CPSSES-200701076
Log # TXX-07106

August 28, 2007

SUBJECT: COMANCHE PEAK STEAM ELECTRIC STATION
DOCKET NOS. 50-445 AND 50-446
LICENSE AMENDMENT REQUEST (LAR) 07-004, REVISION TO THE OPERATING
LICENSE AND TECHNICAL SPECIFICATION 1.0, "USE AND APPLICATION" AND
3.7.17, "SPENT FUEL ASSEMBLY STORAGE" TO REVISE RATED THERMAL POWER
FROM 3458 MWT TO 3612 MWT

~~Figure 3.7.17-4~~
Storage Configurations (4/4, 3/4, 2/4, 1/4) in Region II Racks

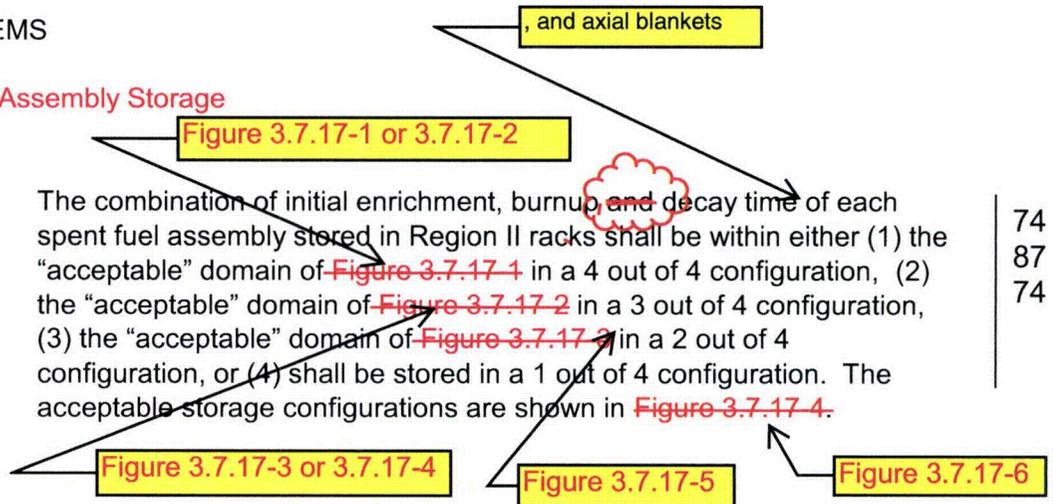
The combination of initial enrichment, burnup, and decay time of each spent fuel assembly stored in Region II racks shall be within either (1) the "acceptable" domain of ~~Figure 3.7.17-1~~ in a 4 out of 4 configuration, (2) the "acceptable" domain of ~~Figure 3.7.17-2~~ in a 3 out of 4 configuration, (3) the "acceptable" domain of ~~Figure 3.7.17-3~~ in a 2 out of 4 configuration, or (4) shall be stored in a 1 out of 4 configuration. The acceptable storage configurations are shown in ~~Figure 3.7.17-4~~.

LCO 3.7.17 The combination of initial enrichment, burnup, decay time, and axial blankets of each spent fuel assembly stored in Region II racks shall be within either (1) the “acceptable” domain of **Figure 3.7.17-1** or **3.7.17-2** in a 4 out of 4 configuration, (2) the “acceptable” domain of **Figure 3.7.17-3** or **3.7.17-4** in a 3 out of 4 configuration, (3) the “acceptable” domain of **Figure 3.7.17-5** in a 2 out of 4 configuration, or (4) shall be stored in a 1 out of 4 configuration. The acceptable storage configurations are shown in **Figure 3.7.17-6**.

Figure 3.7.17-1
Minimum Required Fuel Assembly Burnup versus Initial ²³⁵U Enrichment for the
"4-out-of-4" Storage Configuration

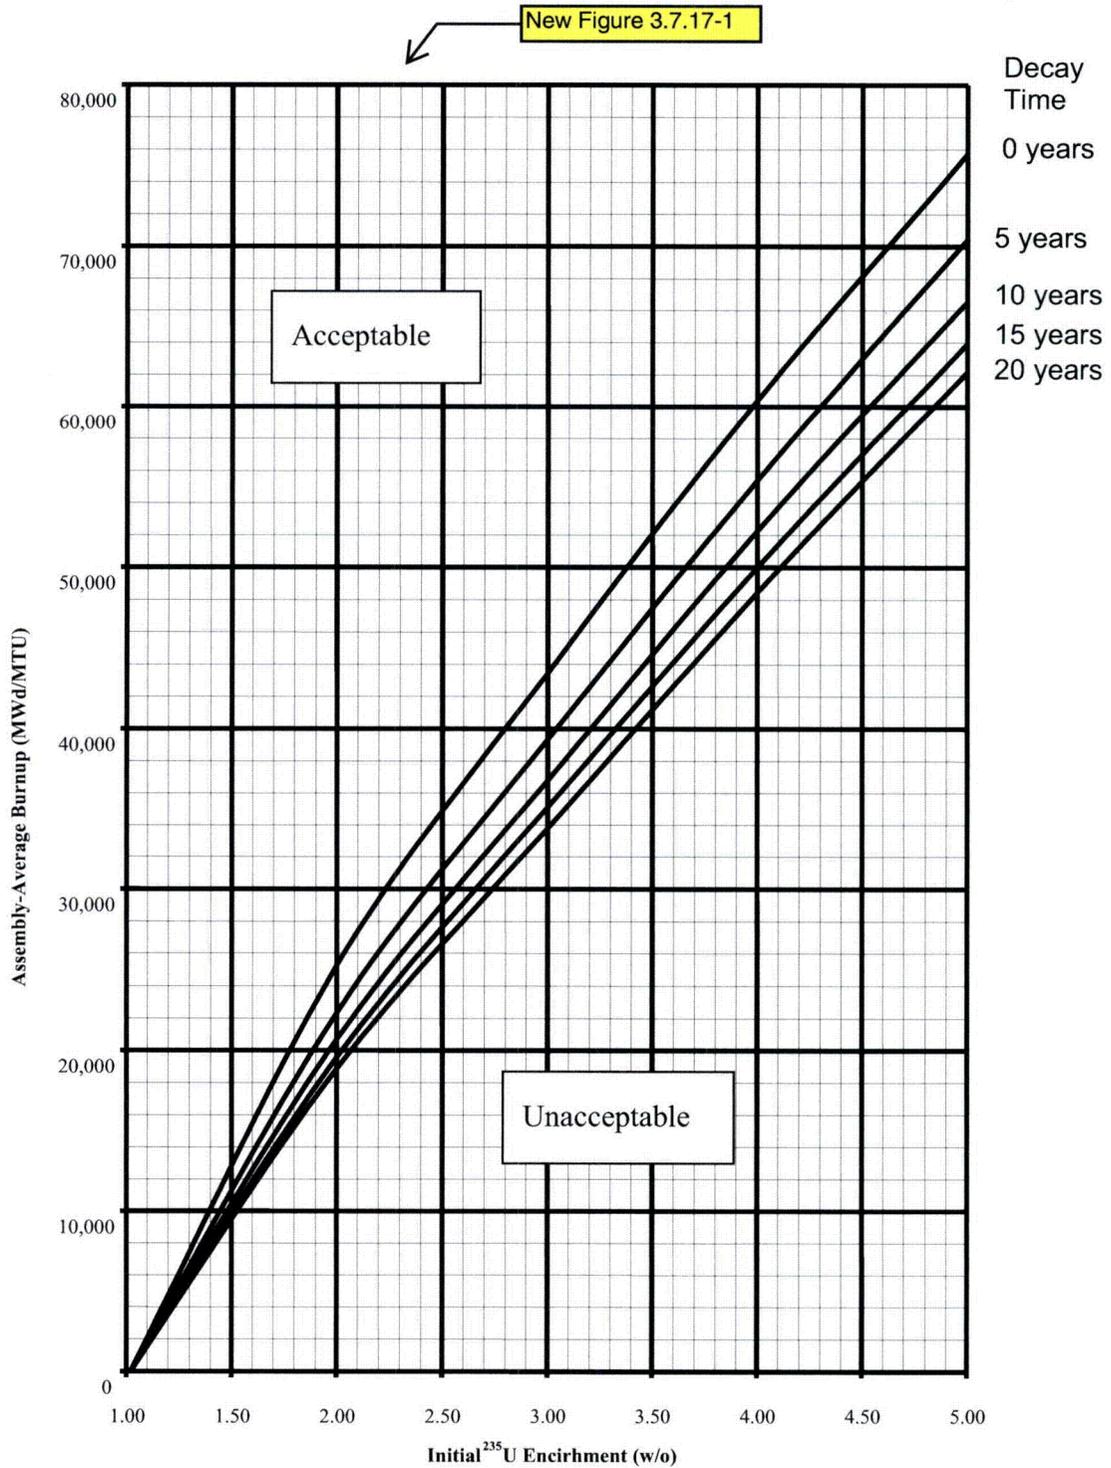
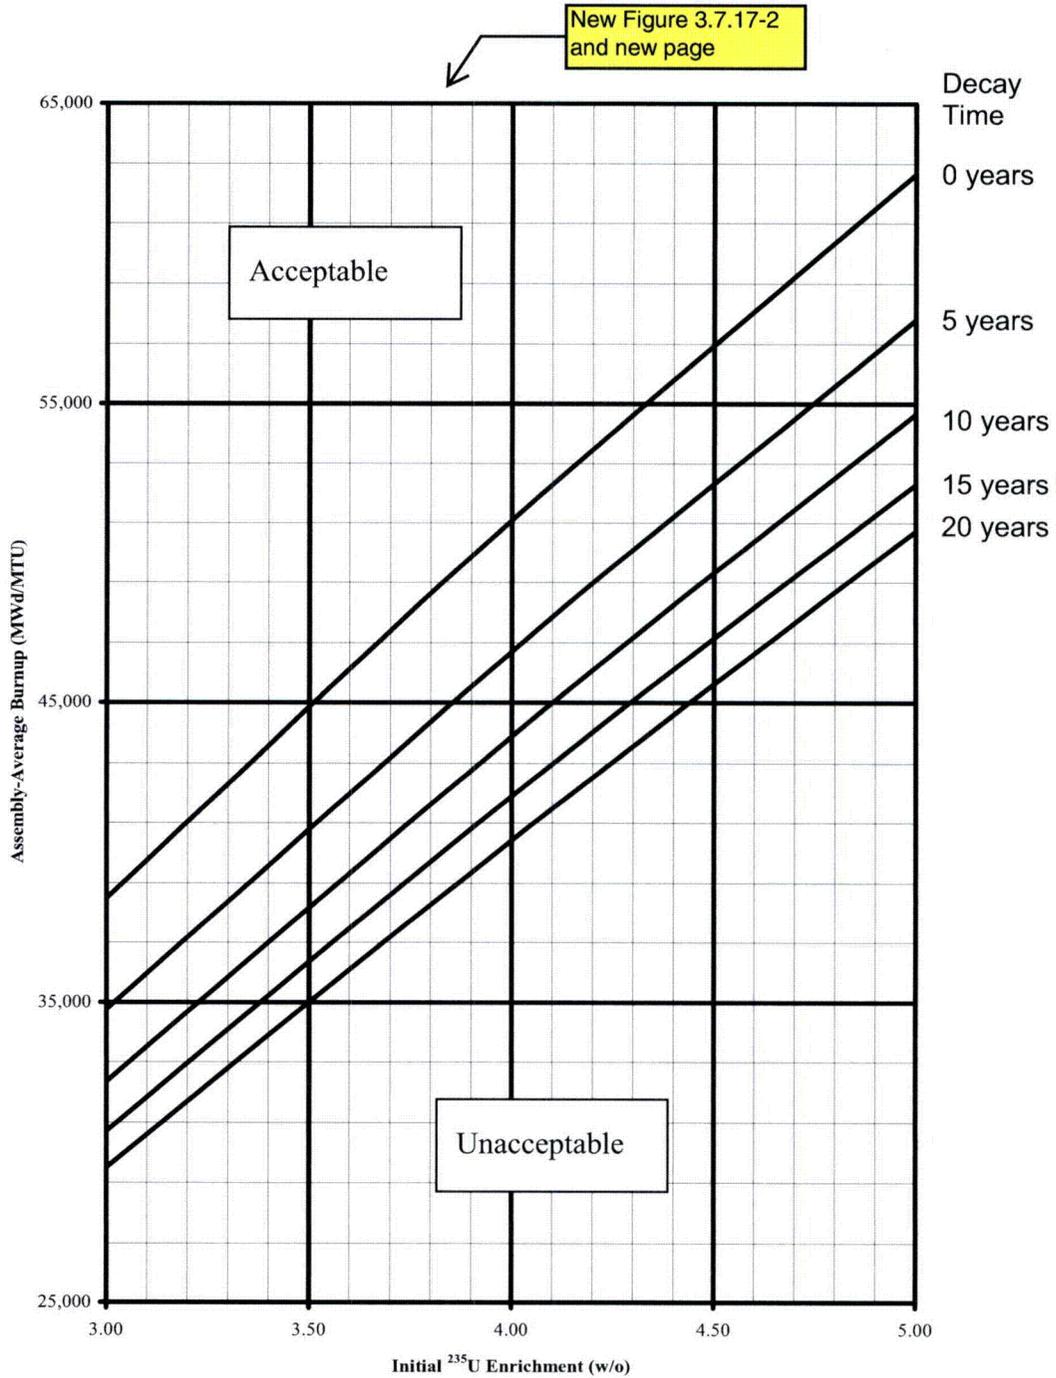
FIGURE 3.7.17-1
 Fuel Assembly Burnup vs. U-235 Enrichments vs. Decay Time Limits
 For a 4 out of 4 Storage Configuration in Region II Racks

- A Region II (4/4), new or partially spent fuel assemblies in the "acceptable" domain of Figure ~~3.7.17-1~~. ← **3.7.17-1 or 3.7.17-2.**
- B Region II (3/4), new or partially spent fuel assemblies in the "acceptable" domain of Figure ~~3.7.17-2~~. ← **3.7.17-3 or 3.7.17-4.**
- C Region II (2/4), new or partially spent fuel assemblies in the "acceptable" domain of Figure ~~3.7.17-3~~. ← **3.7.17-5.**
- D Region II (1/4), new or partially spent fuel assemblies which are stored in an expanded checkerboard (1 out of 4).

Figure 3.7.17-3
Minimum Required Fuel Assembly Burnup versus Initial ²³⁵U Enrichment for the "3-out-of-4" Storage Configuration

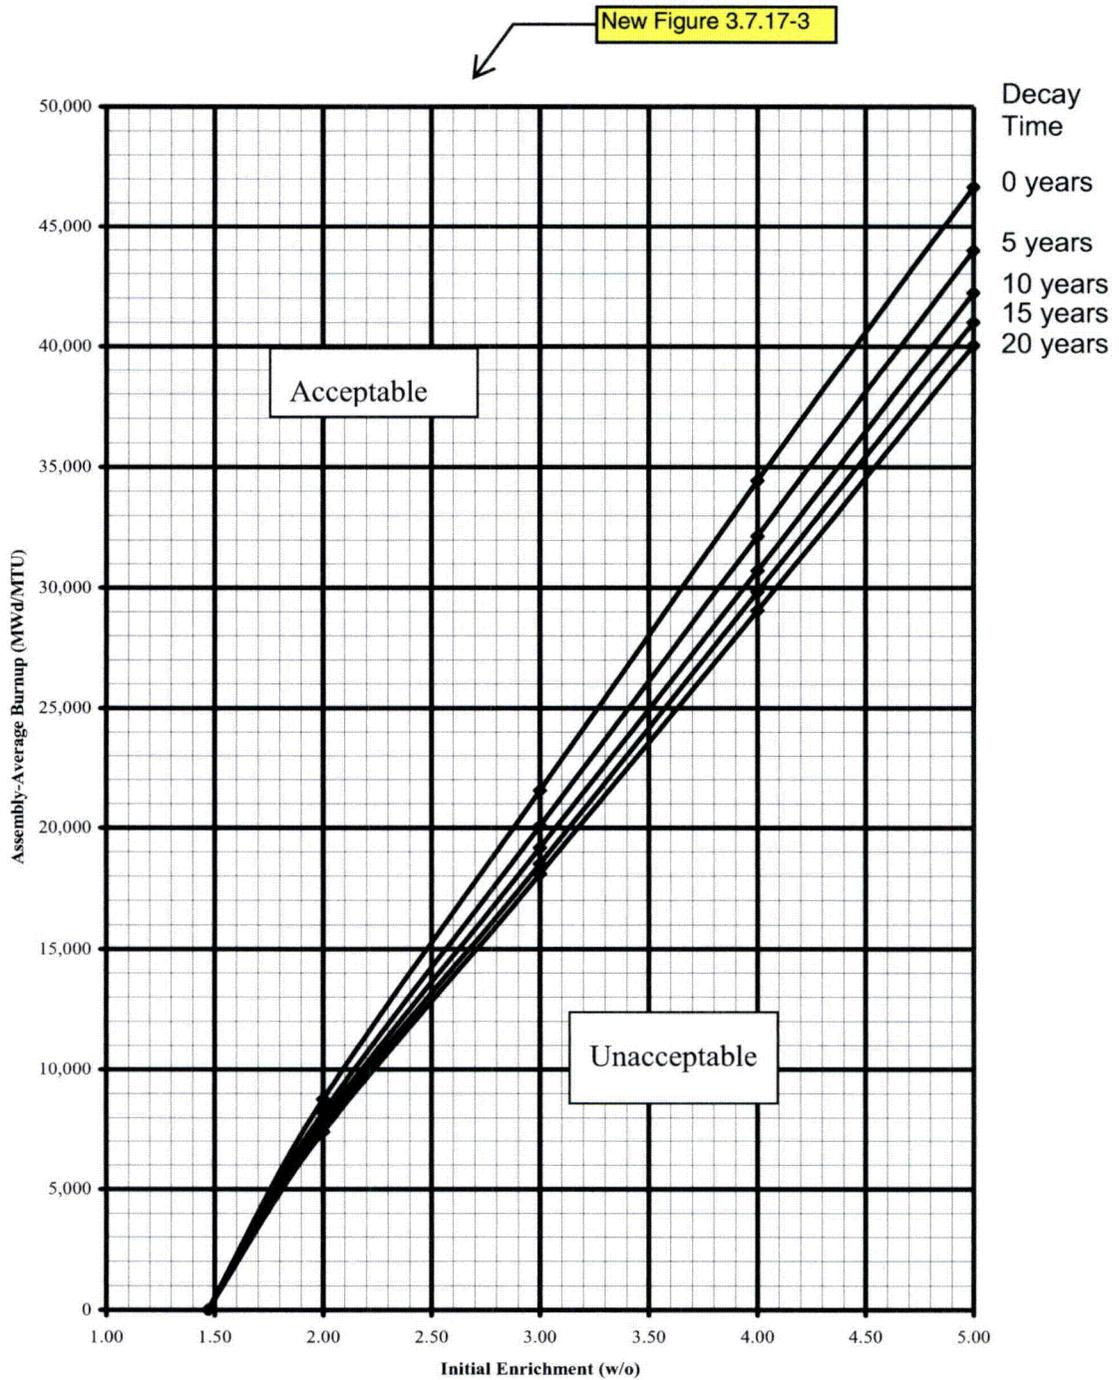
Figure 3.7.17-2
Minimum Burnup vs. Initial U-235 Enrichment vs. Decay Time
For a 3 out of 4 Storage Configuration in Region II Racks

All possible 2 by 2 matrices containing Region II rack cells shall comply with at least one of the following. (1) within the "acceptable" domain of ~~Figure 3.7.17-1~~ in a 4 out of 4 configuration, (2) within the "acceptable" domain of ~~Figure 3.7.17-2~~ in a 3 out of 4 configuration, (3) within the "acceptable" domain of ~~Figure 3.7.17-3~~ in a 2 out of 4 configuration, or (4) a 1 out of 4 configuration.

Figure 3.7.17-4
Minimum Required Fuel Assembly Burnup versus Initial ²³⁵U Enrichment for the
"3-out-of-4 with Axial Blankets" Storage Configuration

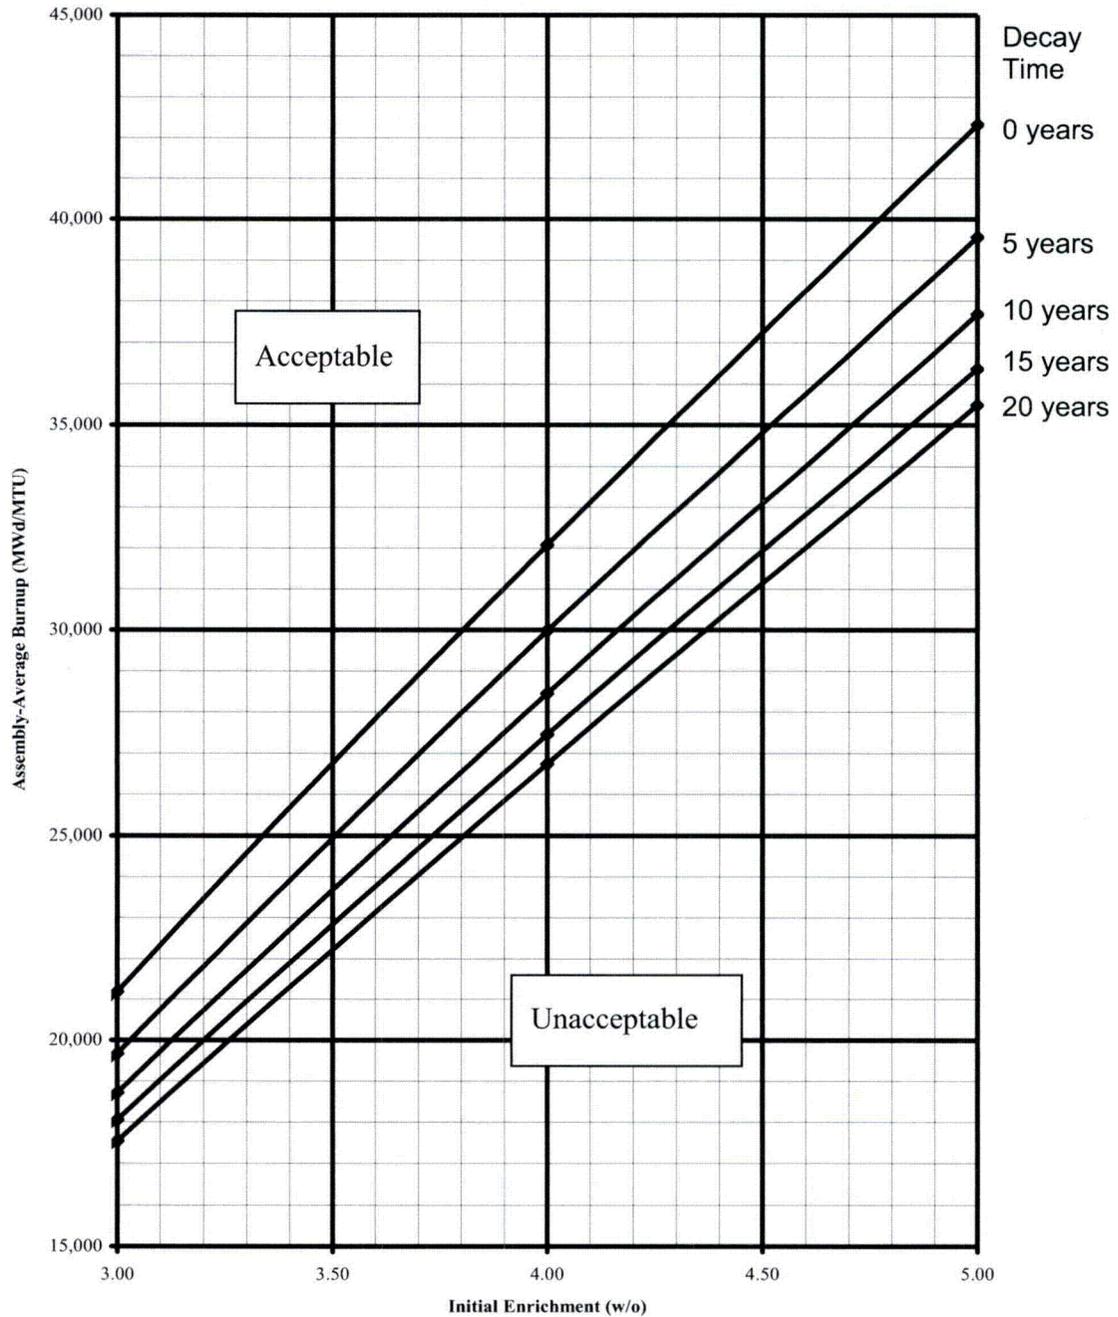
New Figure 3.7.17-4
and new page

Figure 3.7.17-5
Minimum Required Fuel Assembly Burnup versus Initial ²³⁵U Enrichment for the
"2-out-of-4" Storage Configuration

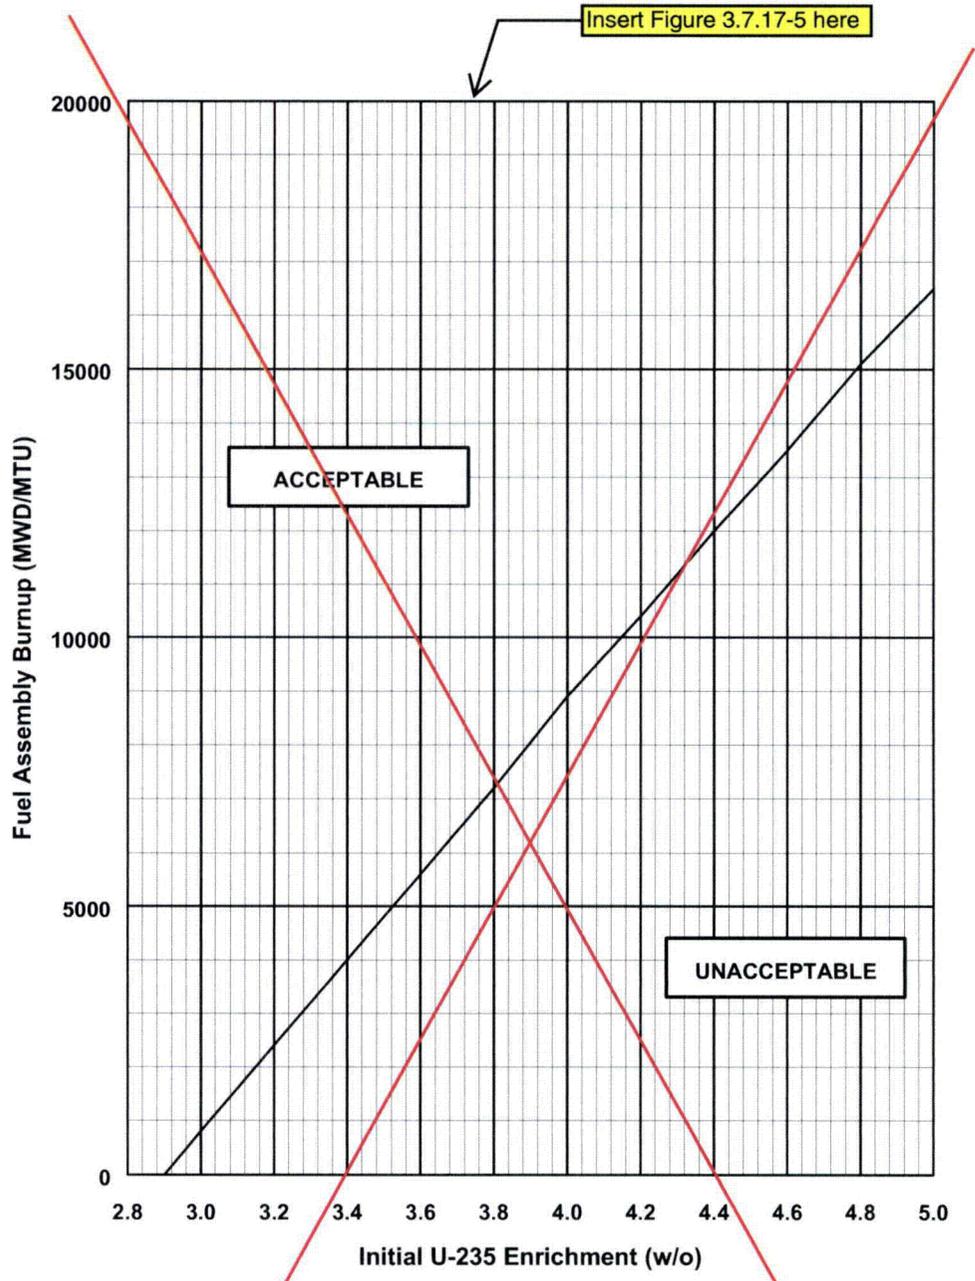
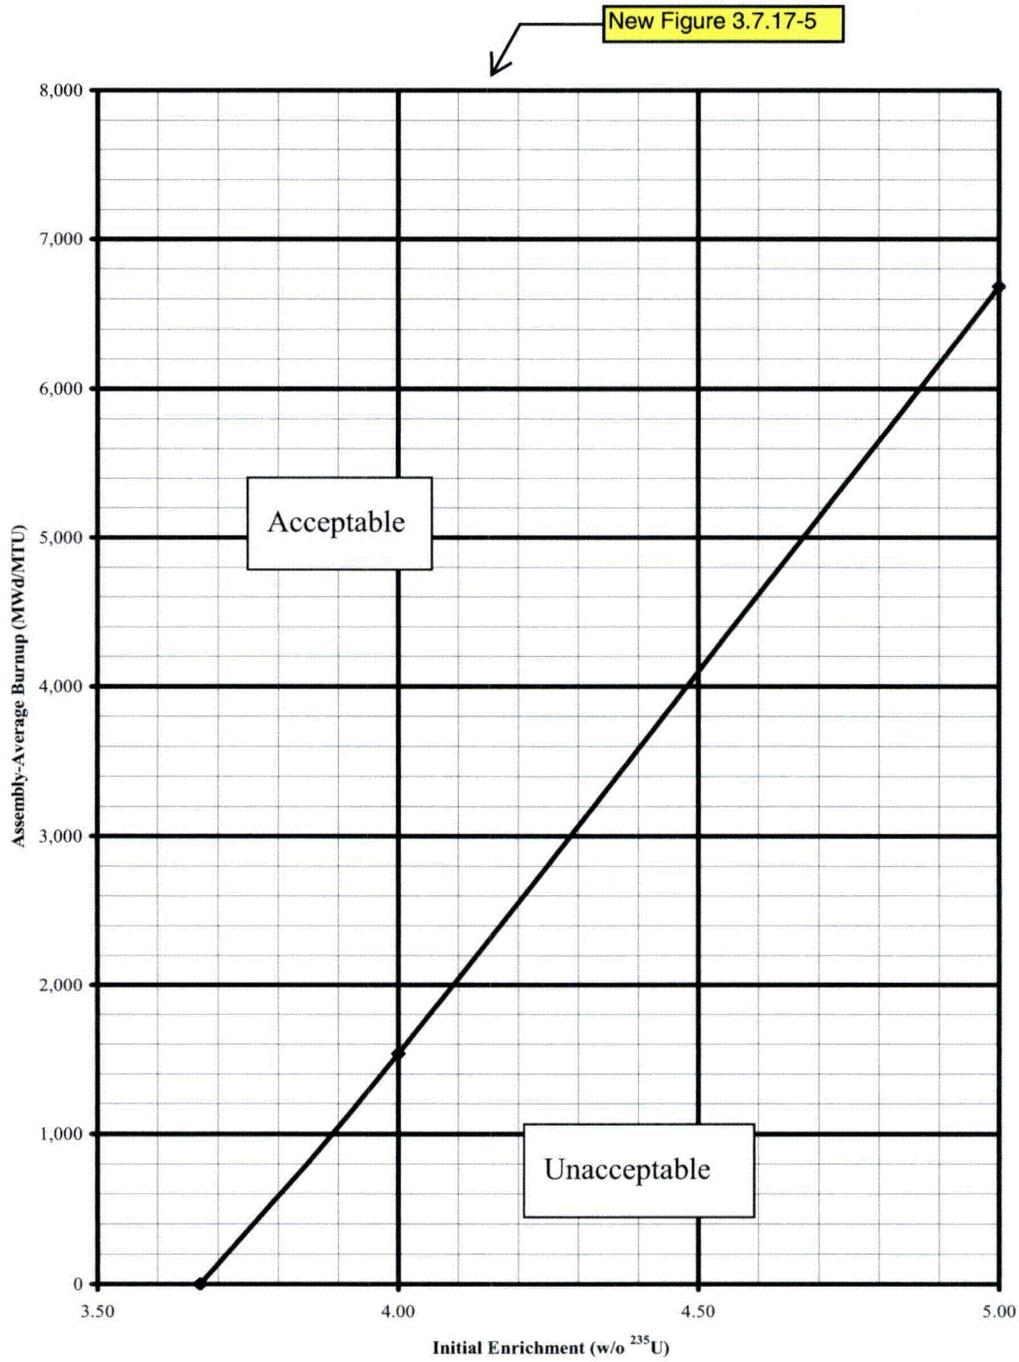
Figure 3.7.17-3
Minimum Burnup vs. Initial U-235 Enrichment
For a 2 out of 4 Storage Configuration in Region II Racks
